Technical Service Bulletin

Transaction No.: **2082615/1**

38 ATF pipes leak - Q7 with 0C8 gearbox

Model(s)	Year(s)	VIN Range	Vehicle Specific Equipment
Q7	2007 – 2014	All	0C8 gearbox

Figure 1. The ATF pipes.

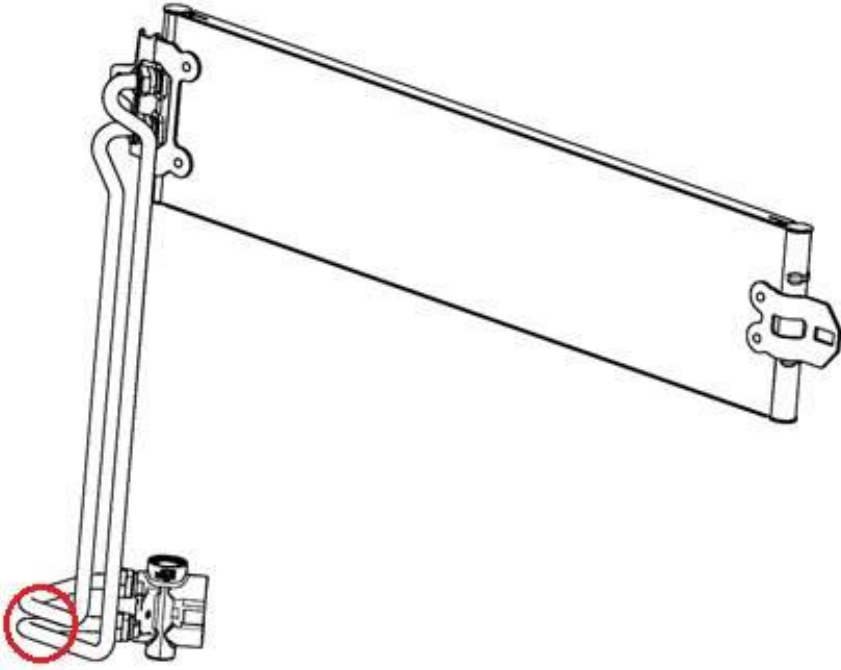
- Leaks around the ATF lines on the automatic gearbox. Visual inspection shows leaking gear oil (ATF) at the connections or along the line.
- During diagnosis, it was found that the ATF lines fitted at the factory were not installed with enough play in the affected area.

The ATF pipes to the cooler (Figure 1) are fed through the sealing section 7L0.121.332.B in the marked area (Figure 2). Under unfavorable circumstances the pipe can touch the sealing section when driving.

When replacing ATF lines, make sure the lines can move freely near the sealing strip.

To avoid the parts touching, cut sealing strip 7L0.121.332.B (right side) by approximately 5 mm as shown in Figure 3.

Cut out the area shown of the sealing section to ensure sufficient clearance of the pipes (Figure 4).

Fit the sealing section and the ATF pipes according to the Workshop Manual.
